ADDENDUM NO. 3

ADDITION TO CROSS POINT BAPTIST CHURCH  
Perry, Georgia

DETAIL 11/S2.0

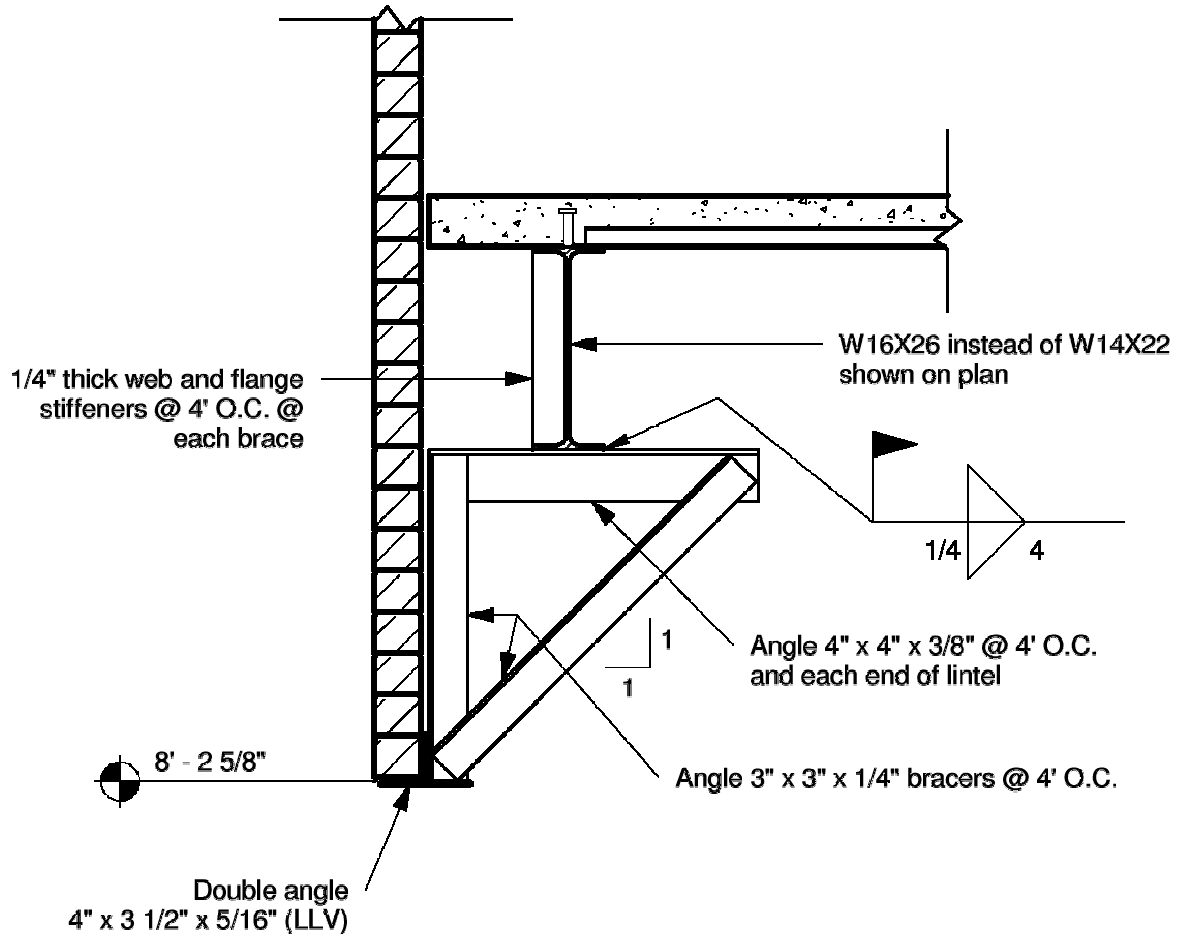
[ADD THE FOLLOWING DETAIL, CUT AT ENTRY 101:

DETAIL 2/S3.0

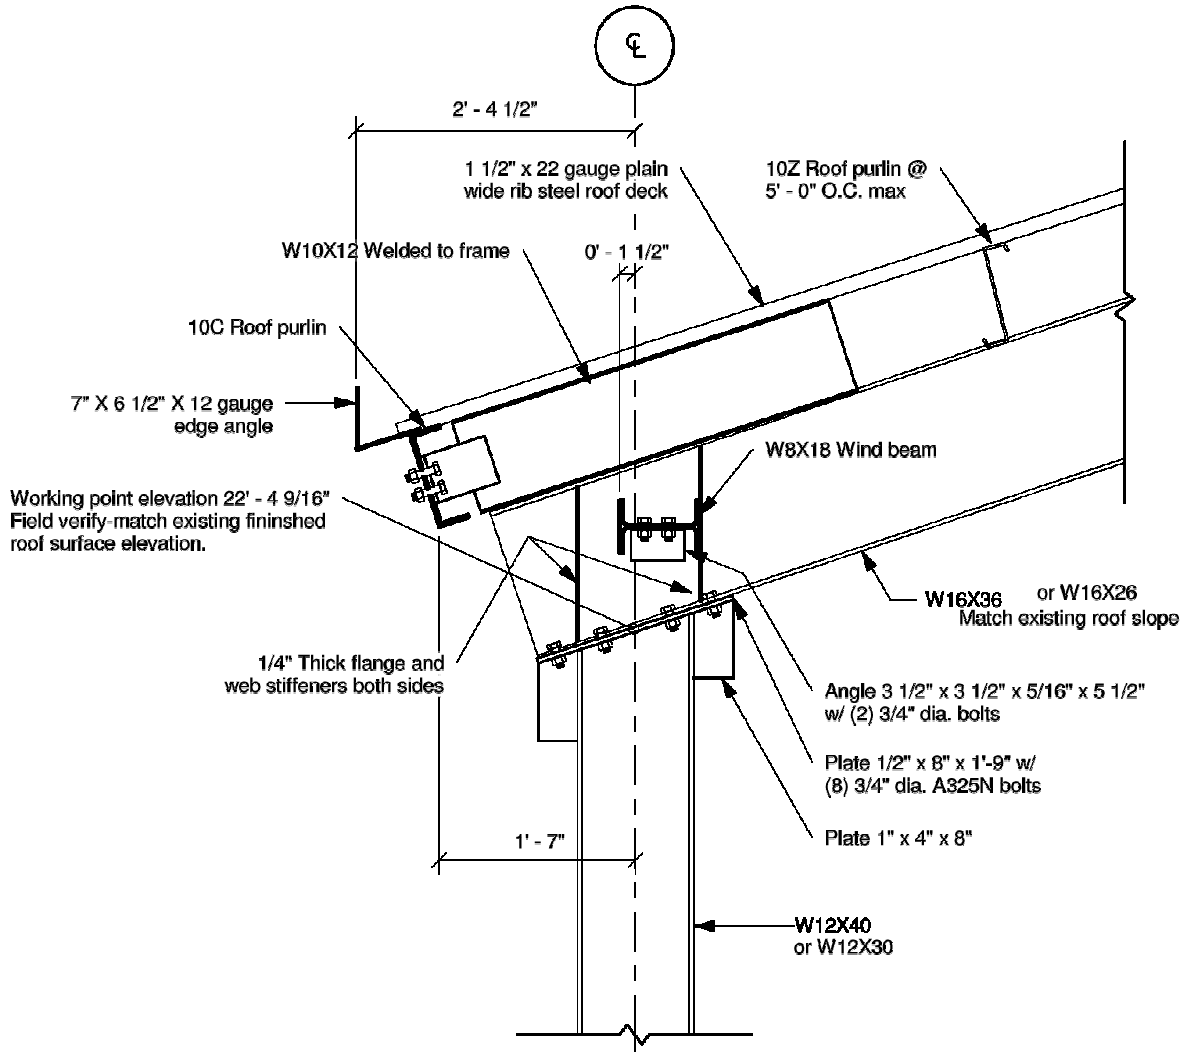
[CHANGE DETAIL AS SHOWN BELOW:

PLAN 1/E2.0

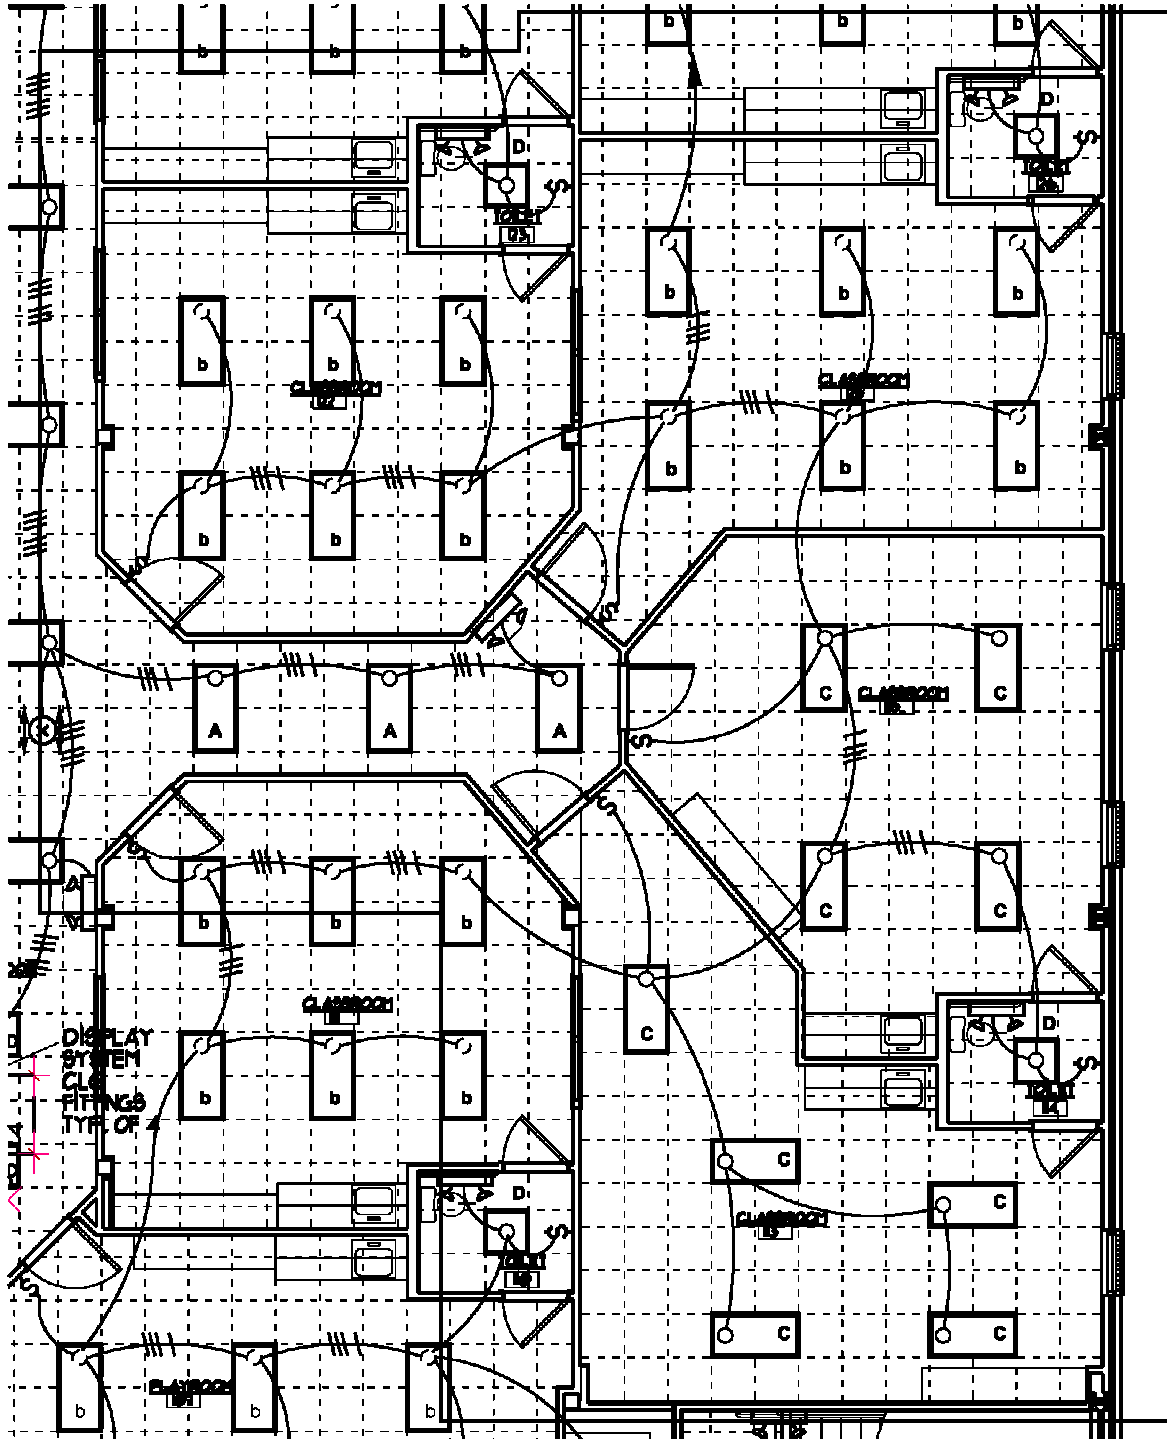
[CHANGE ROOM LAYOUT AS SHOWN BELOW:

PLAN 1/E3.0

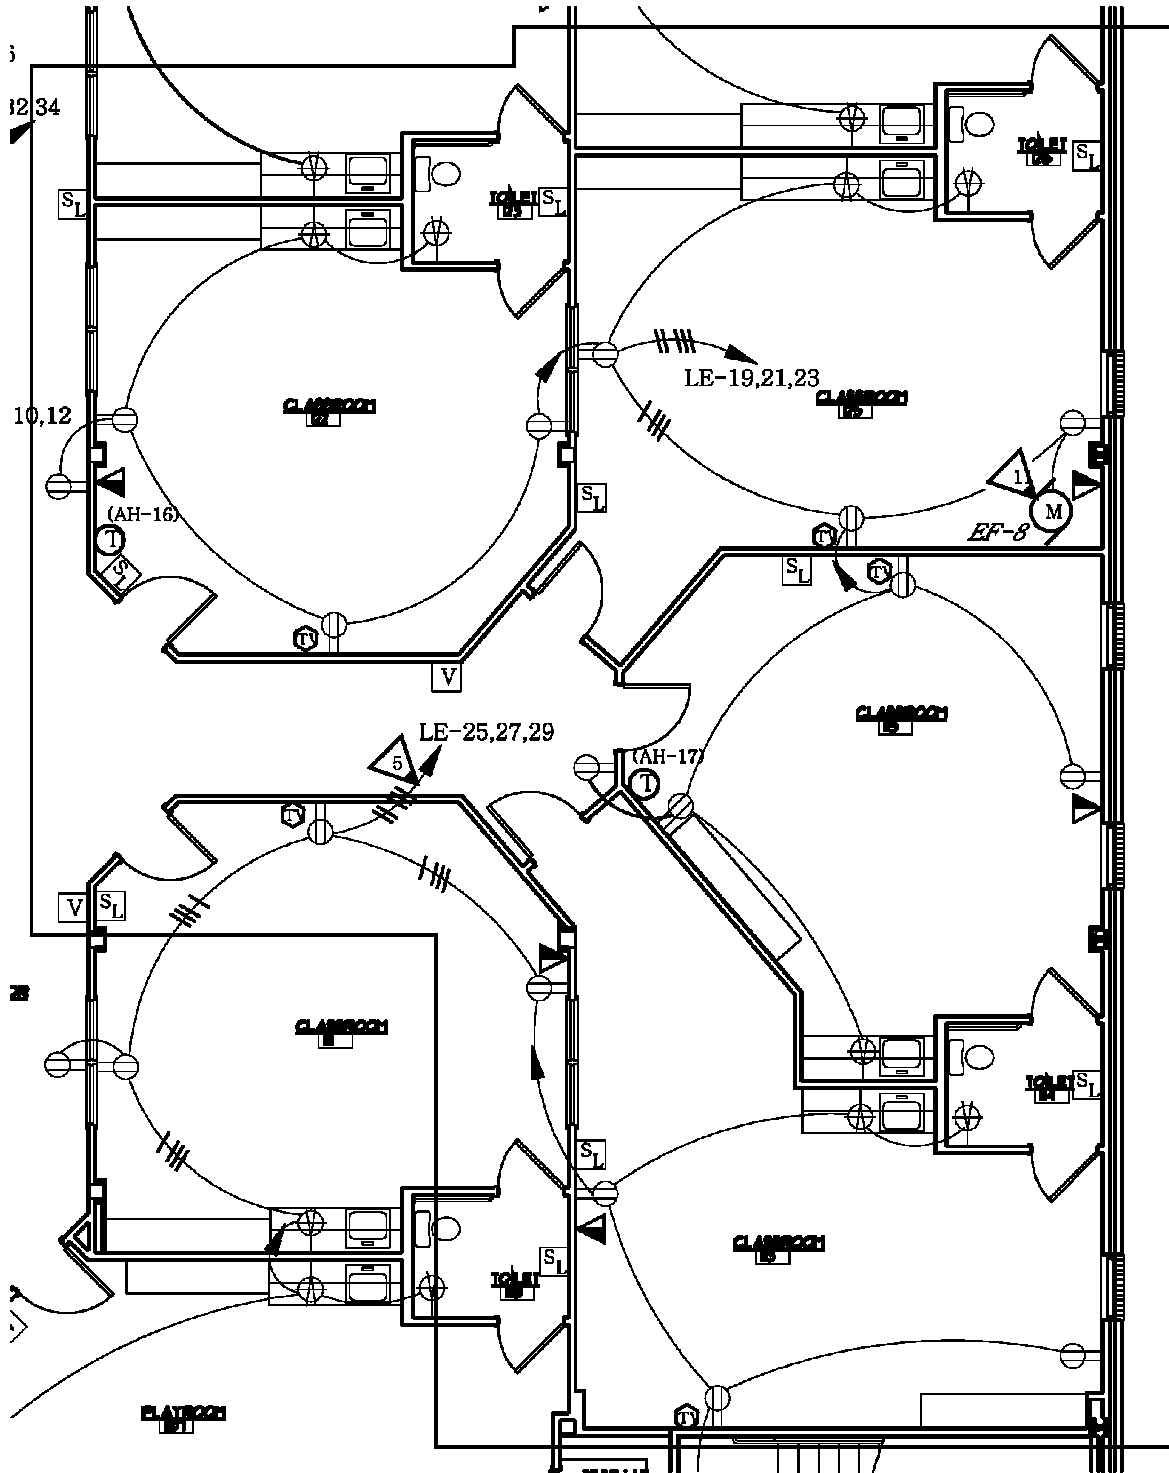
[CHANGE ROOM LAYOUT AS SHOWN BELOW:]
